> Customer Product Information (CPI)

No.: PN21-066

Datasheet drawing unification of SEMIPACK 2 modules

Subject of change: SEMIPACK 2 datasheet drawing

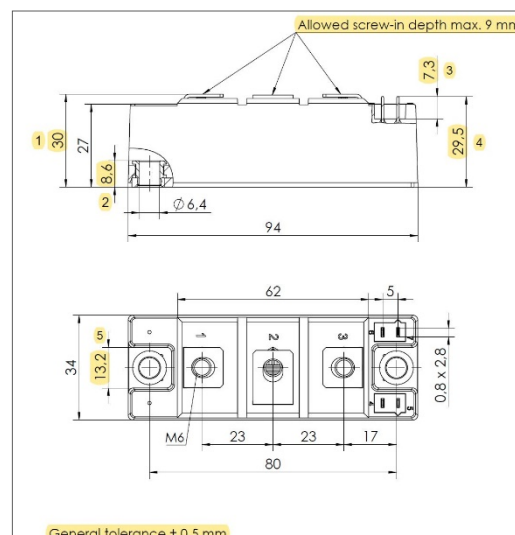
- 1) old $30^{+0.2}\text{mm}$ → new 30mm with general tolerance
- 2) old 8.3mm → new 8.6mm
- 3) old 6mm → new 7.3mm
- 4) old 29mm → new 29.5mm
- 5) old 13mm → new 13.2mm

The dimension of terminal hole depth is replaced by maximum screw-in depth
